ADDENDUM No. 2

PROJECT: University Medical Center
CV/CICU Renovation &
NICU Renovation
602 Indiana Avenue
Lubbock, Texas 79415

DATE: 05/19/2025
PROJECT NO.: 22307 & 22419

UNIVERSITY MEDICAL CENTER CV/CICU & NICU (SIM.) RENOVATIONS SD02: REVISED WINDOW HEAD, JAMB & SILL DETAILS

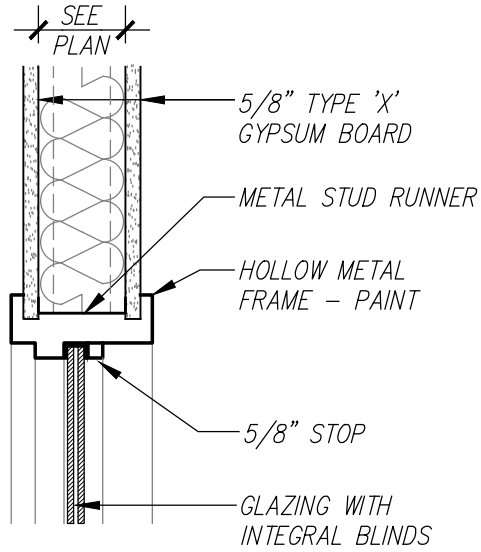
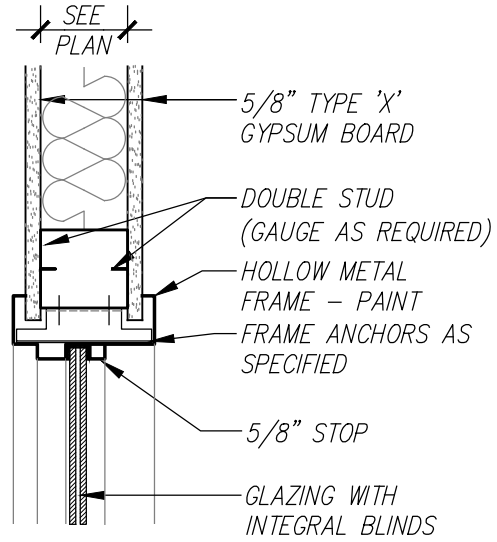
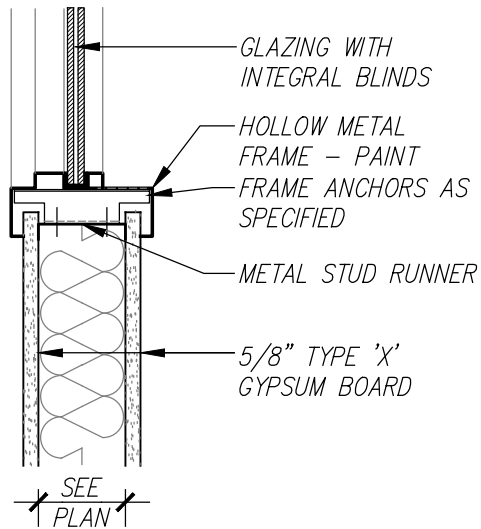
ITEM #2: Window Frame Clarification: Refer to attached Supplemental Drawing SD02 for window details.
